Technical Service Bulletin

MODEL(S) AFFECTED: **V-WD-24P Wet/Dry Vacuum**
Models manufactured before serial number 12443460000000437

SUBJECT: Manufacturer defect - The rod on the pump float switch may be too long which causes the pump to operate continuously when the on/off pump switch is activated. The float switch rod must swing freely without coming in contact with the bottom of the tank to properly activate pump when tank becomes full.

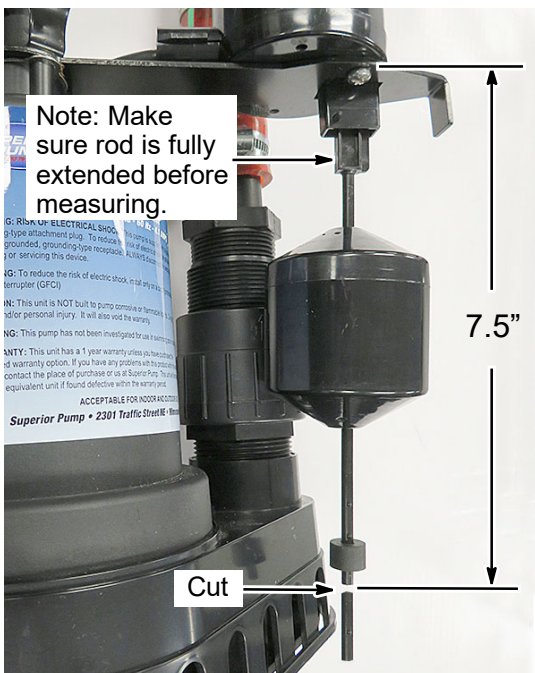
1. Disconnect hose fitting to remove pump assembly from tank.
2. Position pump assembly as shown.

PURPOSE: To repair machine, slide up the rubber stop on the float switch rod and cut rod as described below. The rod is plastic and can easily be cut with cutting snips.

3. Measure 7.5" as described below and cut off remaining length of float switch rod as shown.

4. Reinstall pump assembly.
